Addendum No. 4

November 30, 2018

**R. M. T. Johnson Elementary School
Renovations & Additions
500 Whittlesey Drive
Bethel, CT 06801
State Project No. 009-0059 RNV
Phase 1 of 2**

DWG./SPEC. REFERENCE: A-213/3

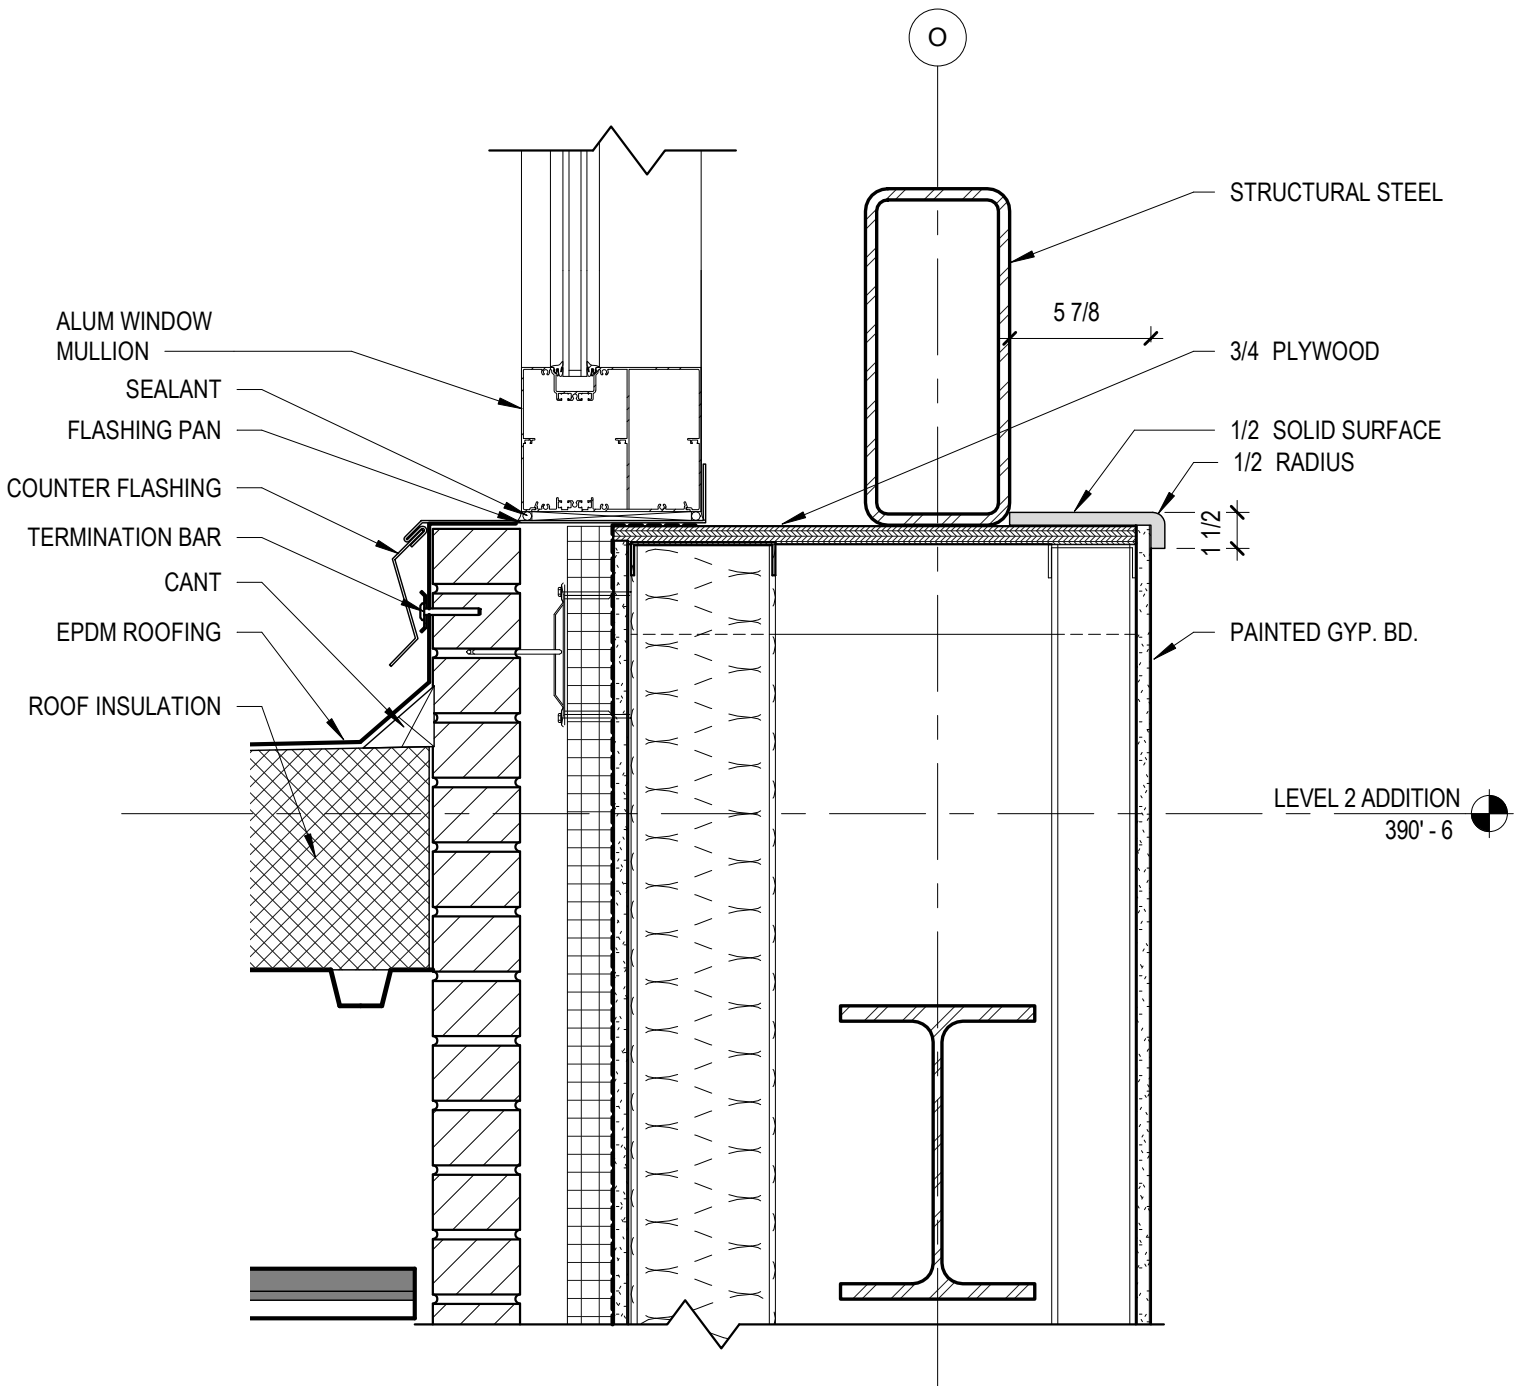
There is a note on elevation A-213/2 for solid surface at the top of the wall in 124 Media Center. No section detail is provided. Please provide more information including dimensions, profile, and which solid surface colour.

SUBJECT: Sound Attenuators
DISCIPLINE/TRADE: BP#15 – HVAC
DWG./SPEC. REFERENCE: M-102A, M-103A, M-103B, M-103C

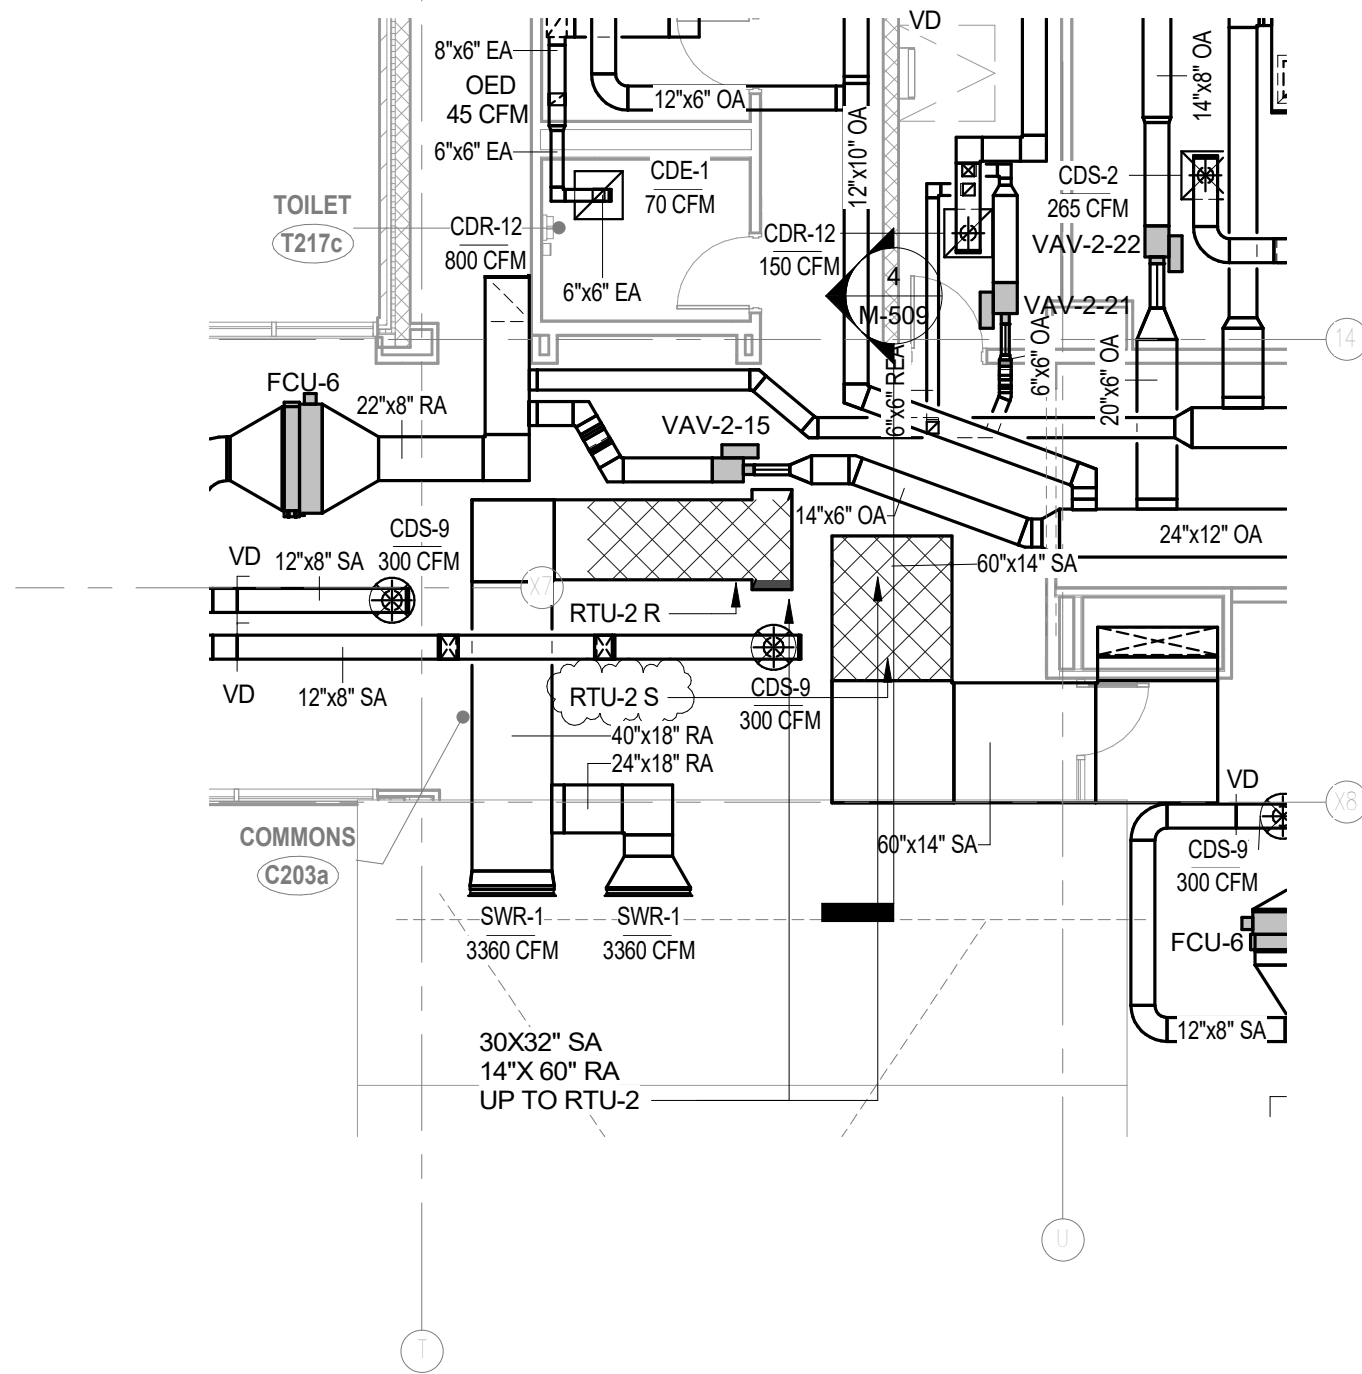
On drawing numbers M-102A, M-103A, M-103B, M-103C there is a grid pattern noted on the ductwork drawings. The key note symbol notes sound attenuators but there are none noted or spec'd. Please advise.

SKM-1

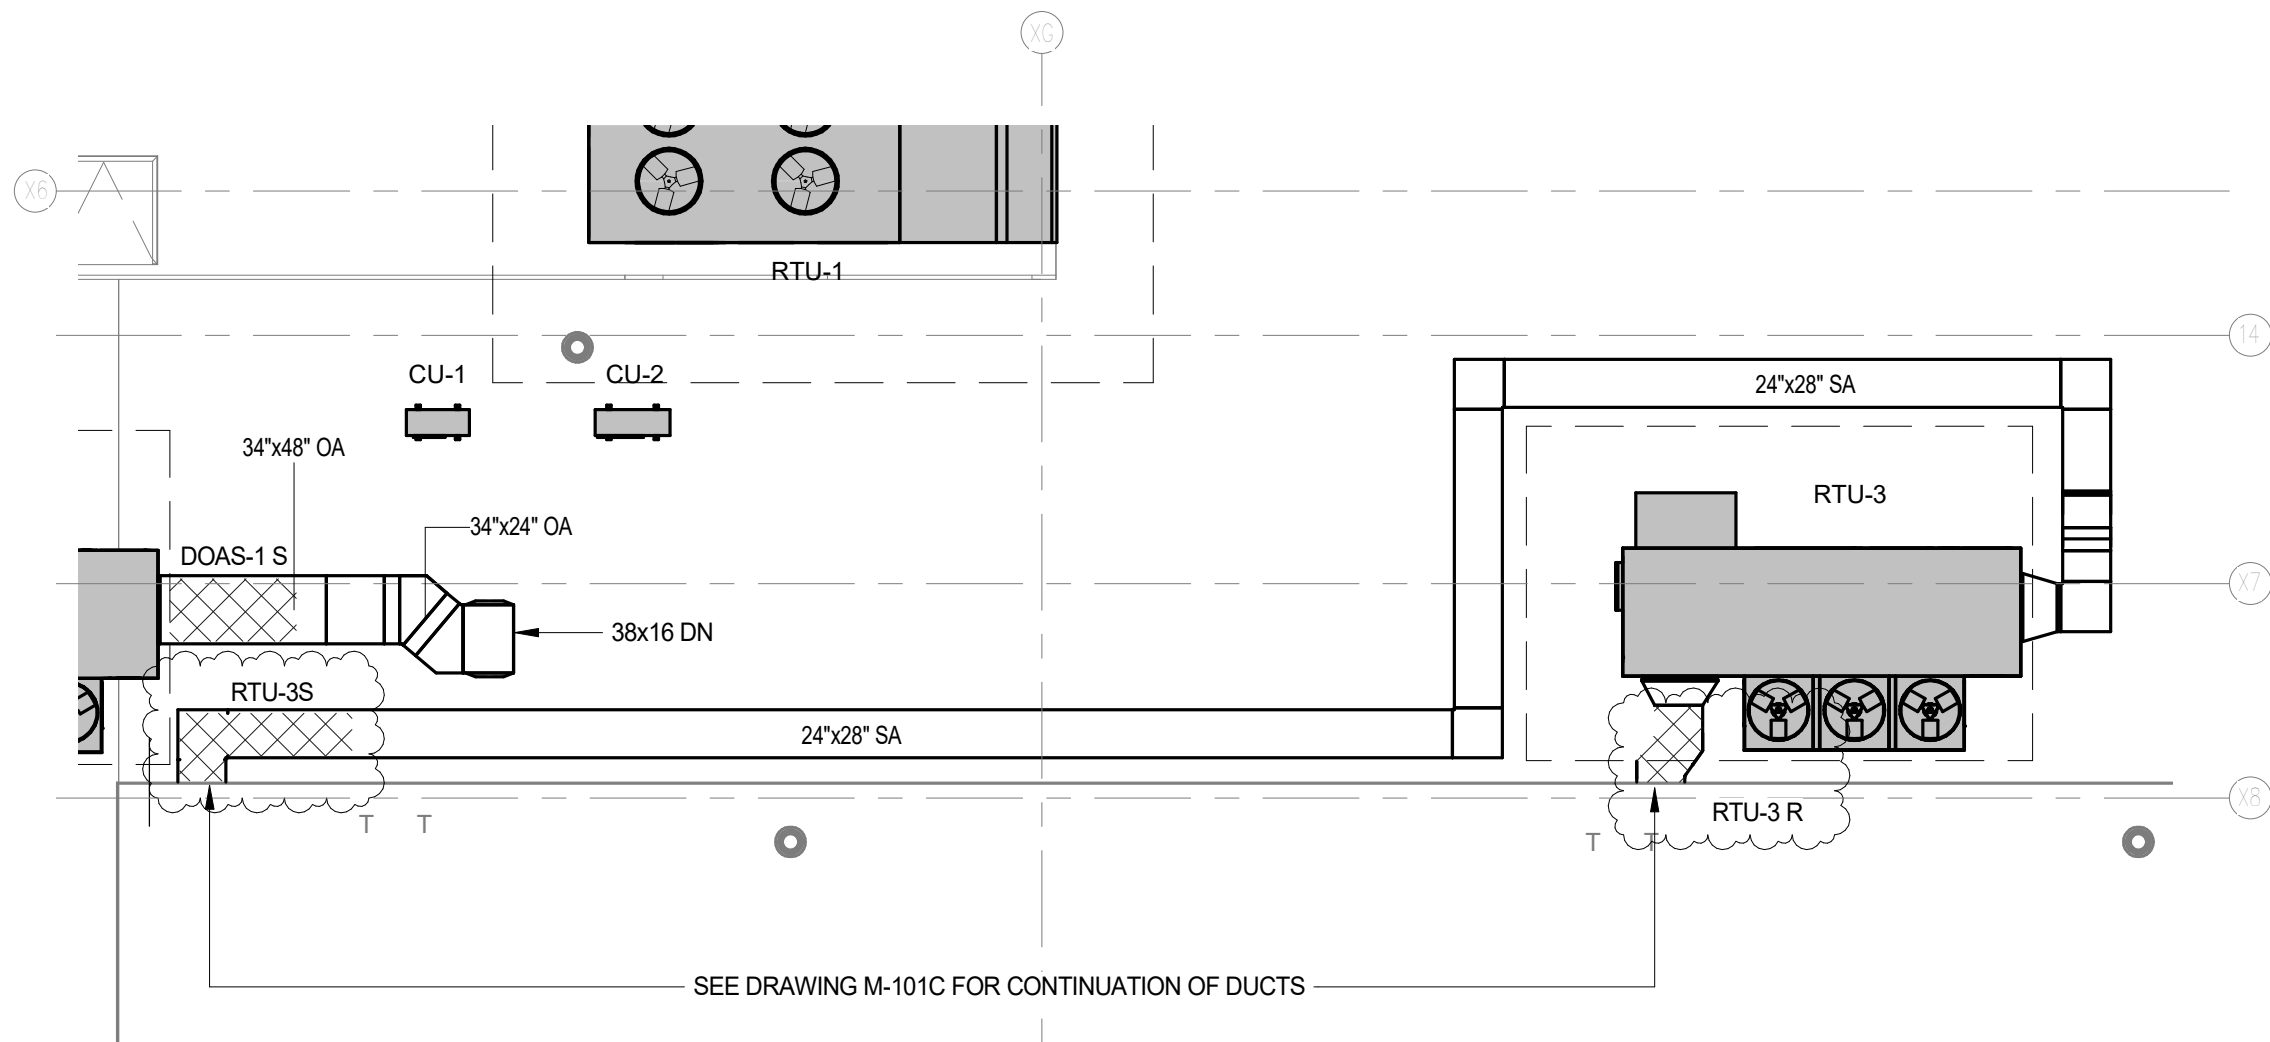
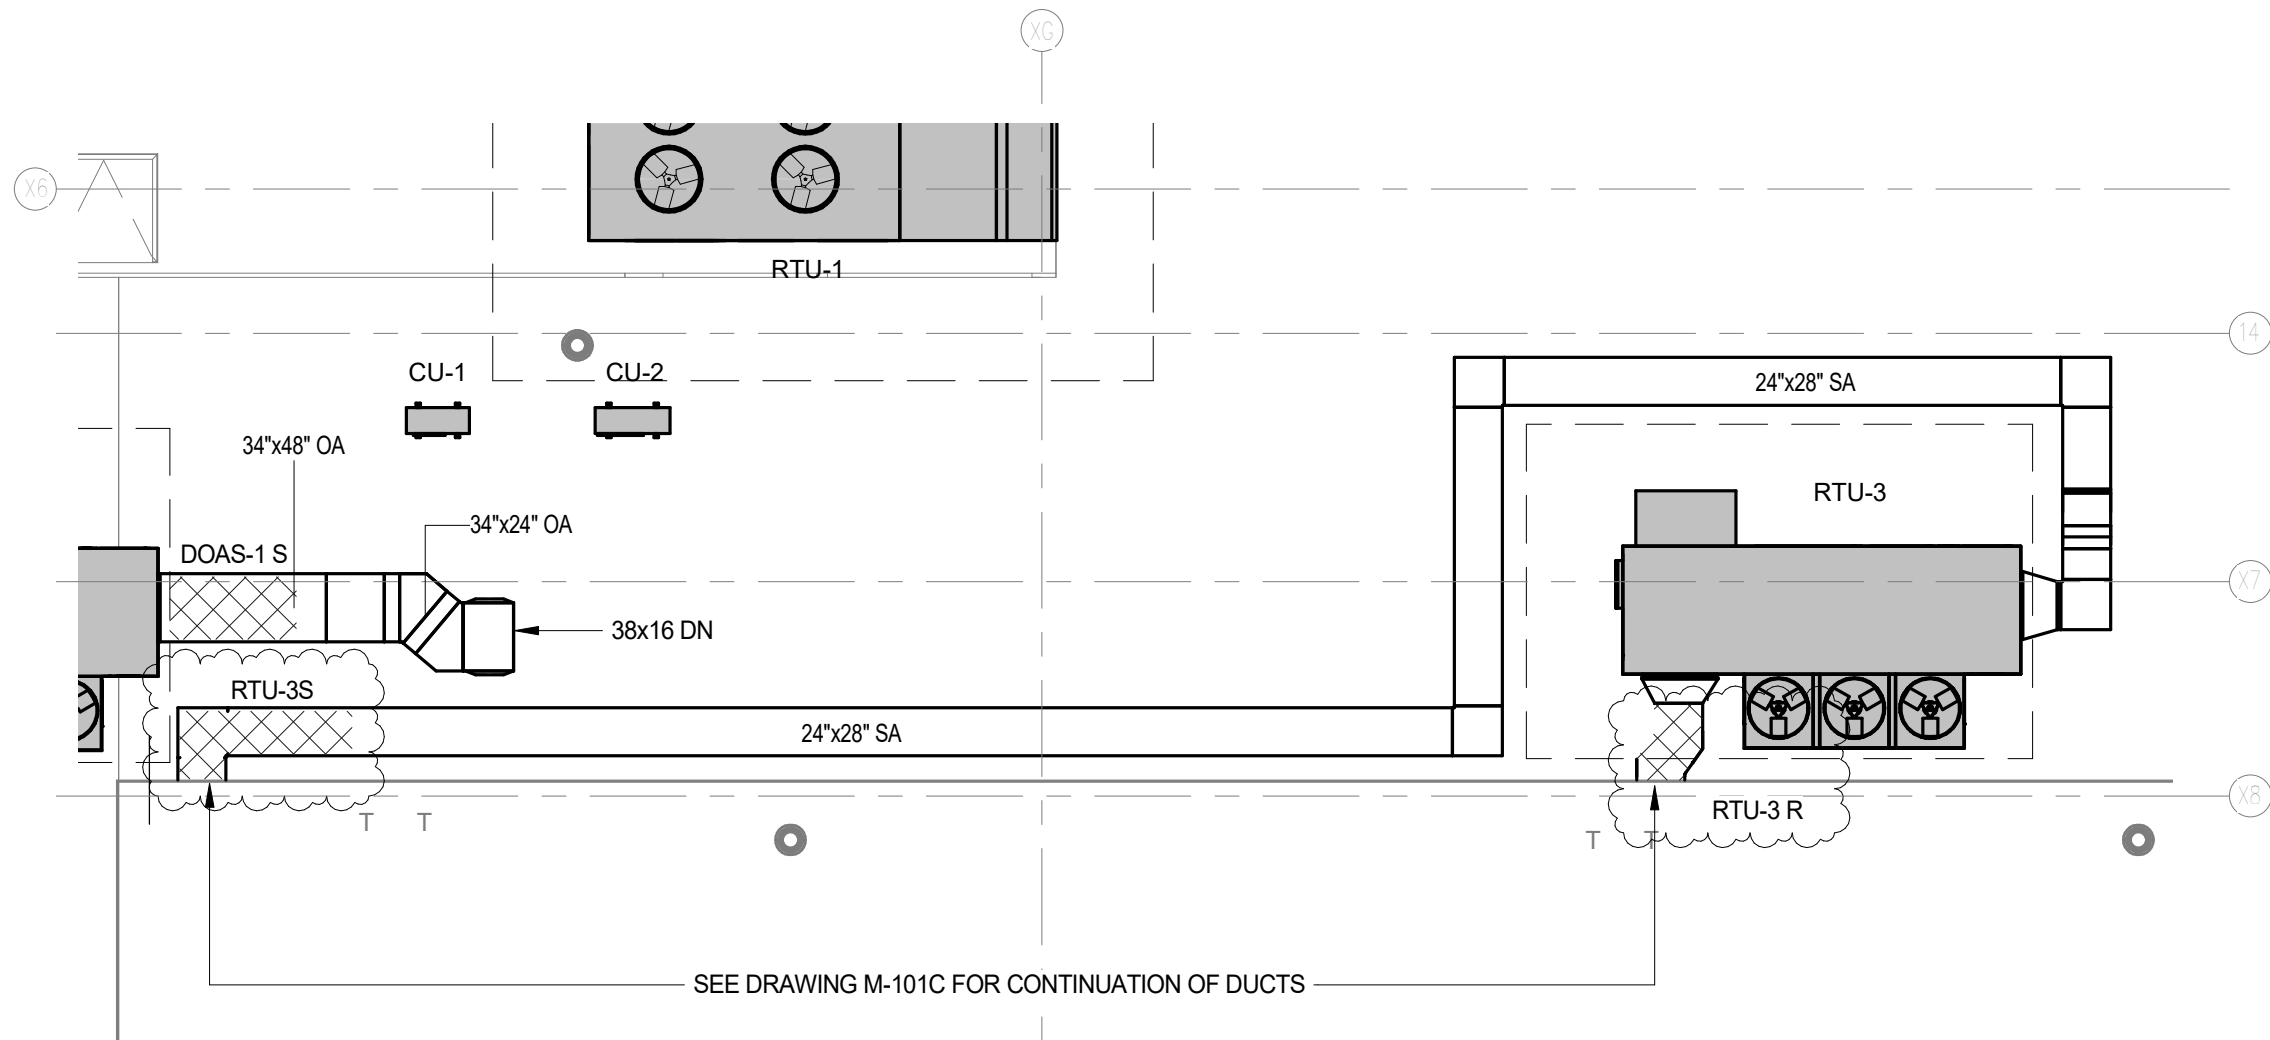
Duct silencer annotations added per sketch SKM-1.

SKM-4

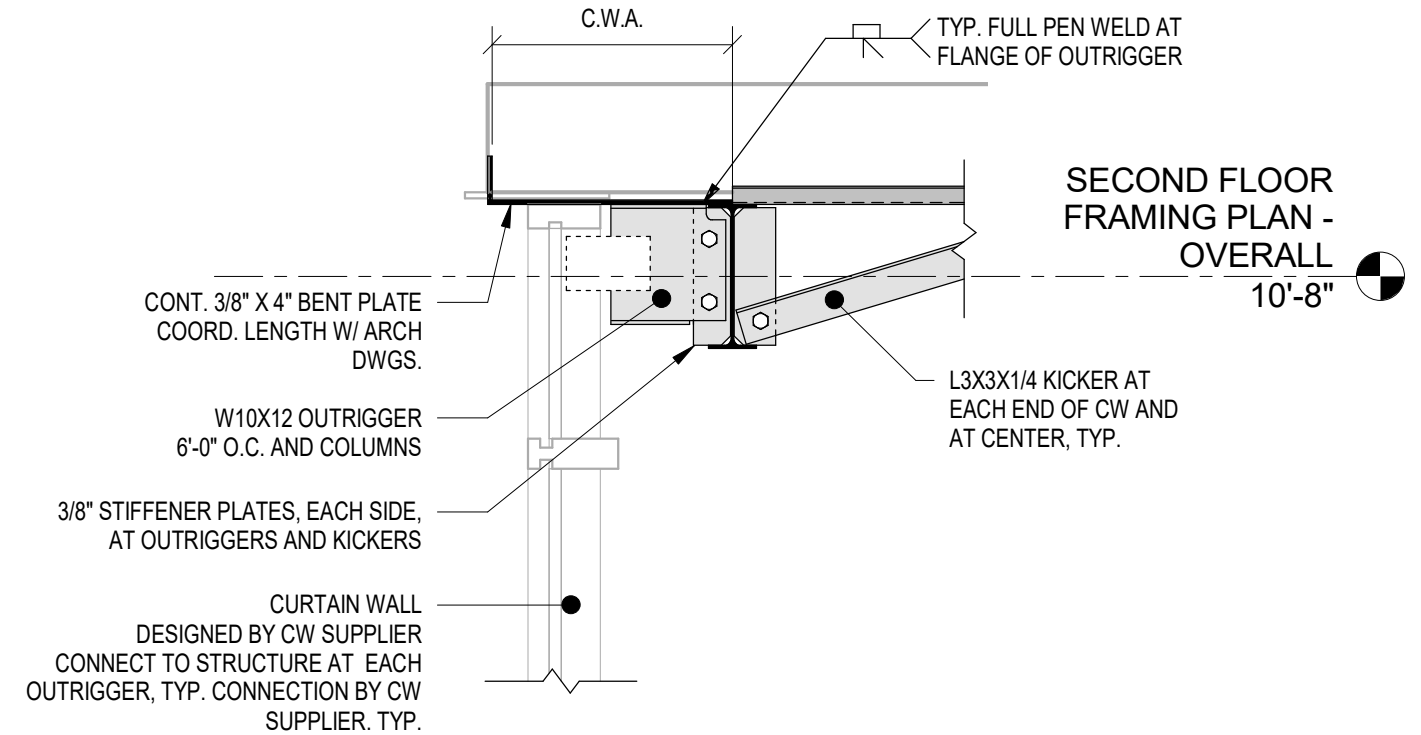
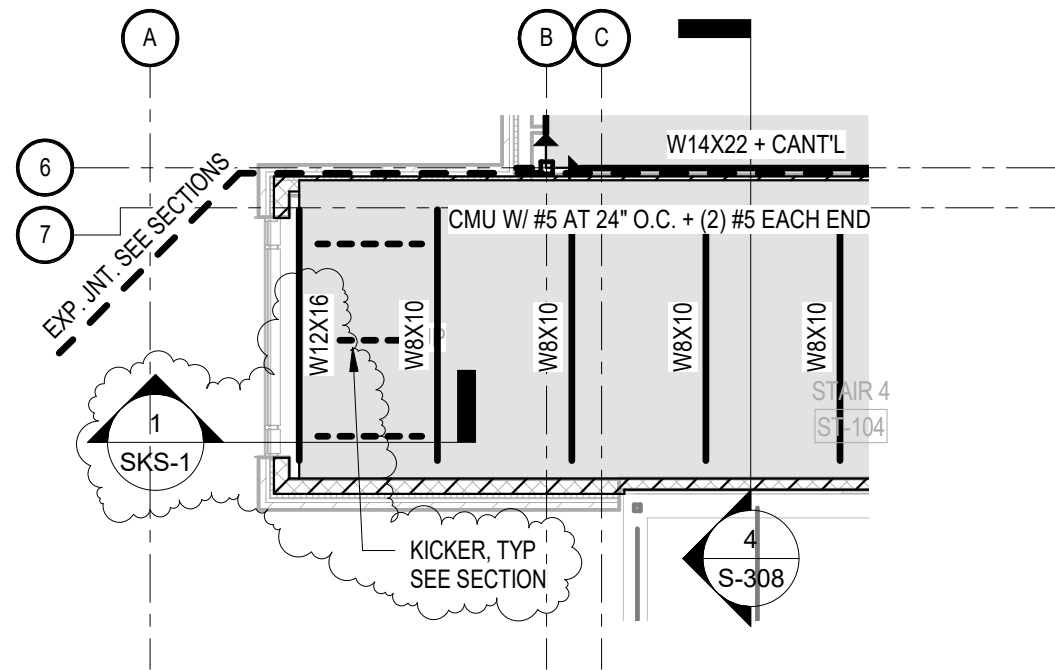
CP-1 and CP-2 revised in Condensate Pump Schedule per sketch SKM-4.

SKS-1

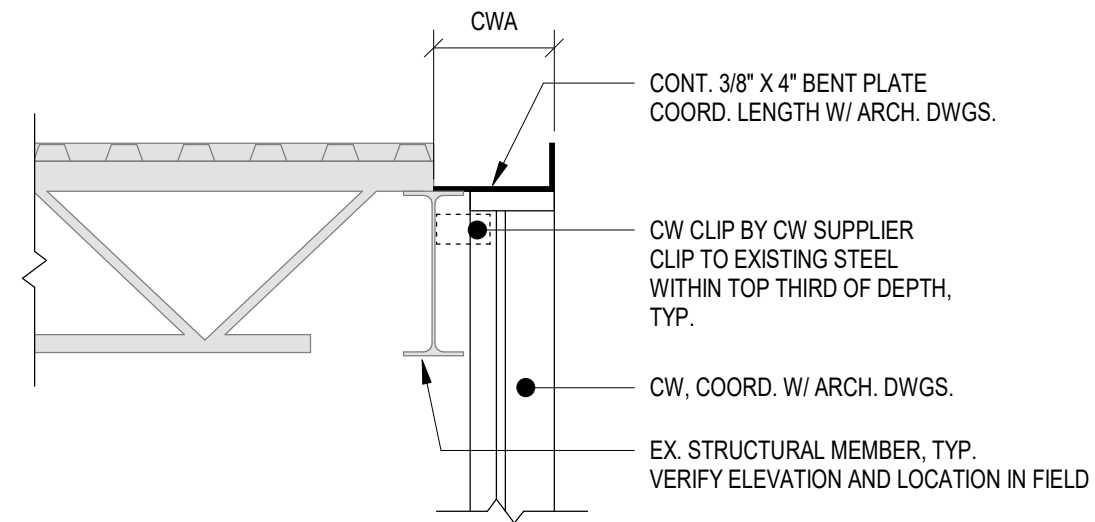
Change W8x10 to W12x16 at exterior face of STAIR 4. Show opening in masonry and kickers for curtain wall. Provide section to connect top of curtain wall to structure. See sketch SKS-1.
